Change to SB121 Family C Pin

The C-pin on all cranes of the SB121 family of sidelifter models has been changed in order to increase the clearance between the pin head and the gland of the bottom lift cylinder when stowed.

Figure 3 – New Pin PN-39219

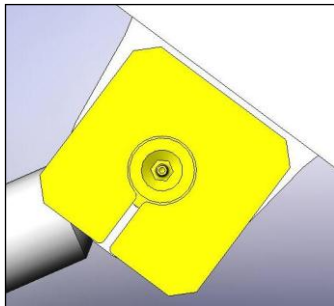
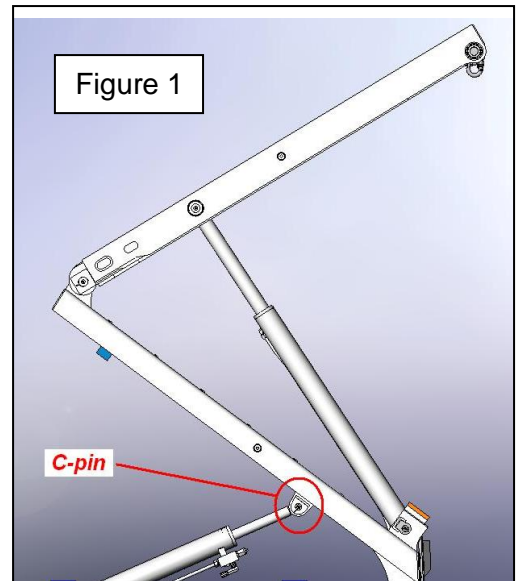
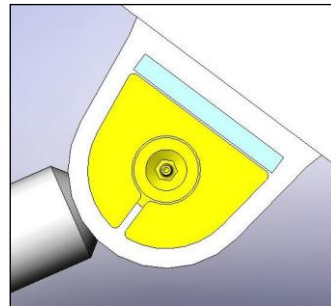
C-Pin PN-32540 has been replaced by PN-39219

The new pin design is located by a 10mm square mild steel bar (shown blue in figure 3) which has been added to the c-pin lug. If an old pin is used with a new bottom arm the square retainer bar will have to be removed or the pin head has to be cut down as shown in figure 4. If a new pin is fitted to an old bottom arm then a retaining bar will have to be welded to the lug as shown in figure 5.
